MONTGOMERY COUNTY HISTORIC PRESERVATION COMMISSION
STAFF REPORT

Address:	5701 Achille Lane, Rockville	Meeting Date:	9/4/2024
Resource:	Master Plan Site #22/25 <i>James H. Cashell Farm</i>	Report Date:	8/28/2024
Applicant:	Robert Bertrand	Public Notice:	8/21/2024
Review:	HAWP	Tax Credit:	Yes
Permit Number:	1080225	Staff:	Laura DiPasquale
Proposal:	Door Replacement

Figure 1: The subject property, outlined in blue, with the 2016 house, original tenant house, and relocated original barn identified in yellow.

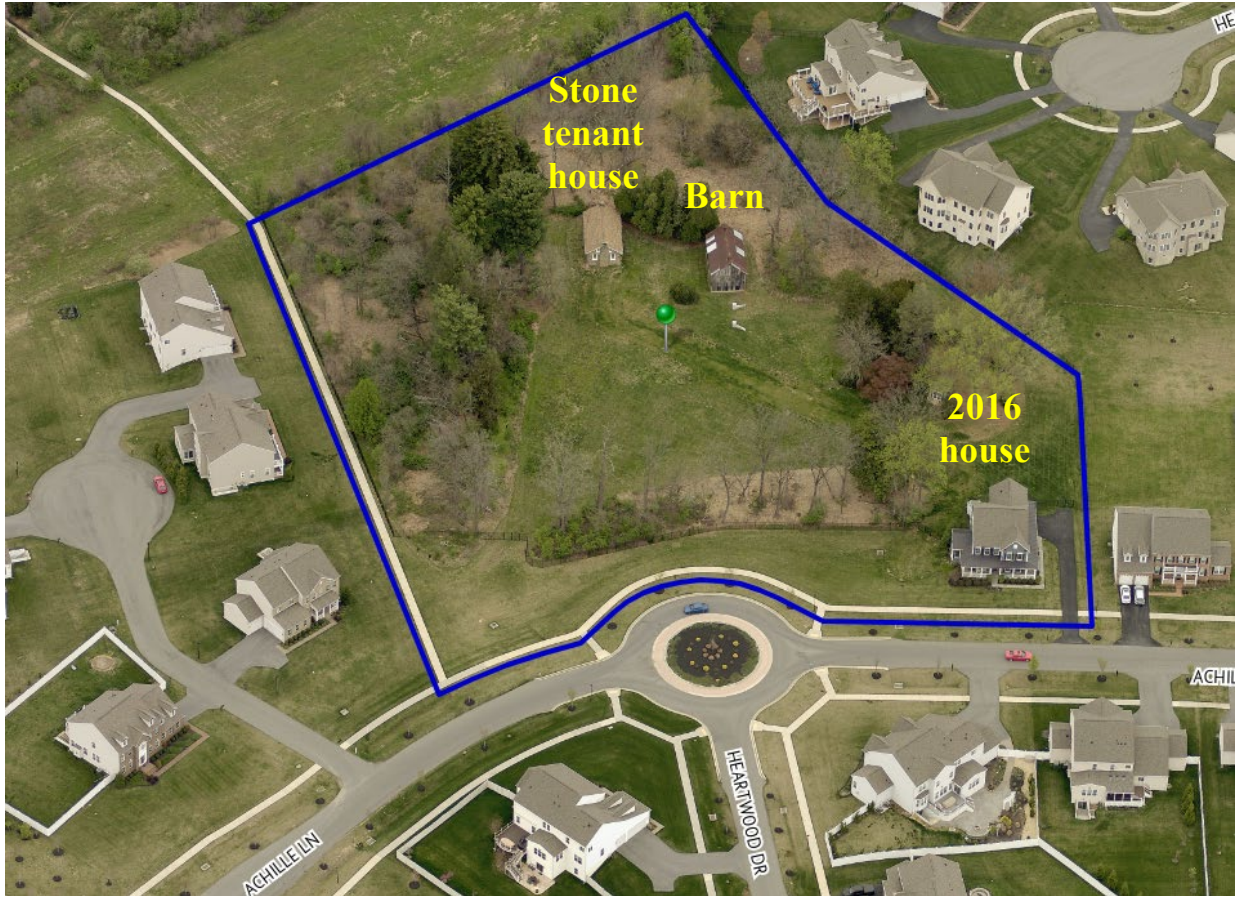
Figure 2: The stone tenant house, with the door proposed for replacement (center).

Figure 3: The existing wood door and masonry opening (left) and proposed door (right).

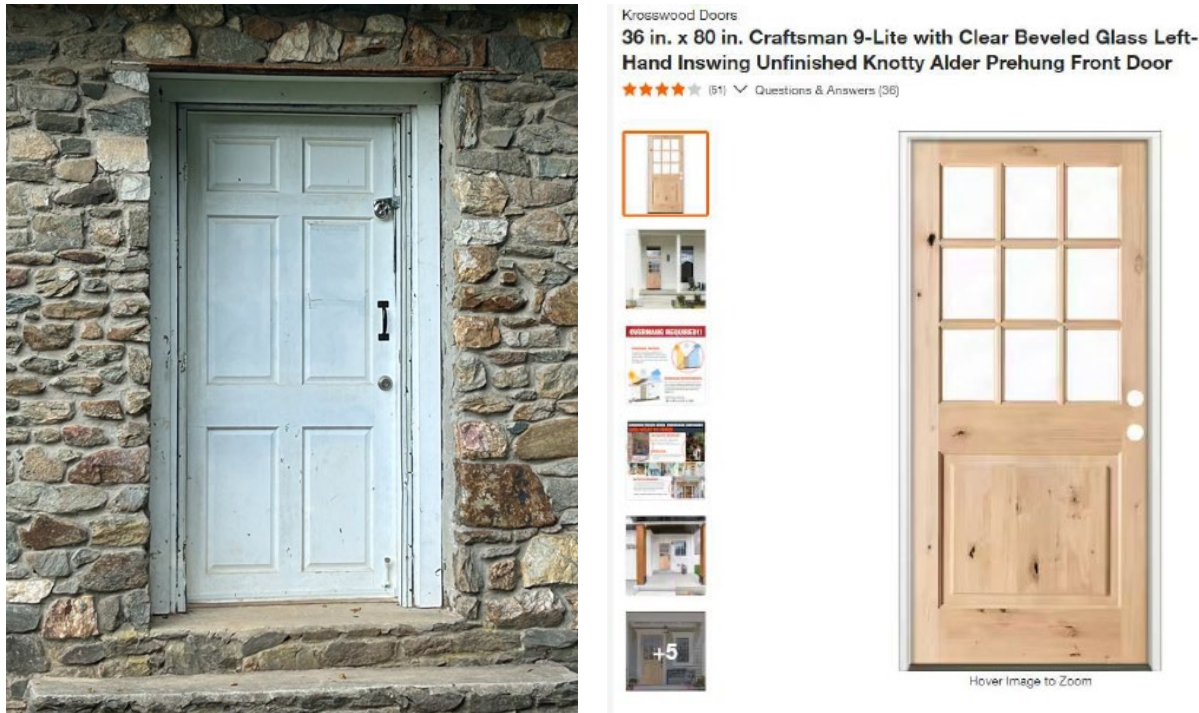
The applicant proposes to replace the existing six-panel wood front door of the contributing stone house with a new pre-hung wood door with six simulated-divided lights over a single panel.

Staff supports the proposed door replacement. Staff finds that the existing door is a prehung unit set within a wider, flat frame, and was installed around 2014. According to the 1996 Maryland Historical Trust survey form for Cashell Farm, the existing stone building was constructed around 1940. A photograph of the property from 1985 shows a six-panel door matching that of the existing door behind a storm door. That door was removed between 1996 and 2008.¹ The application identifies the existing door as dating to 2014, having been approved as part of the broader HPC-reviewed rehabilitation and new construction project for the Cashell Farm under the previous address of 5867 Muncaster Mill Road, and was conditioned, “windows and doors of the Tenant House to be fabricated of wood, with existing frame to be used where feasible.”² The proposed door is wood, in keeping with that stipulation.

Staff finds that, provided the pre-hung door is appropriately sized so as not to further modify the masonry opening or build down the opening, is set to an appropriate depth within the opening, and is painted wood, the proposed replacement door will not substantially alter the historic character of the site and is compatible with the historic site and should be approved under 24A-8(b)(1) and (2). Likewise, the proposal as modified by the above conditions, would retain the historic character of the property, satisfying Standard 2.

1. The door must be installed with the existing or similar setback, with no additional build-down of the frame, and painted to match the surrounding trim. If the applicant determines the existing frame needs to be replaced, they must submit shop drawings showing how the new frame and door will be installed within the masonry opening in elevation, section, and plan.
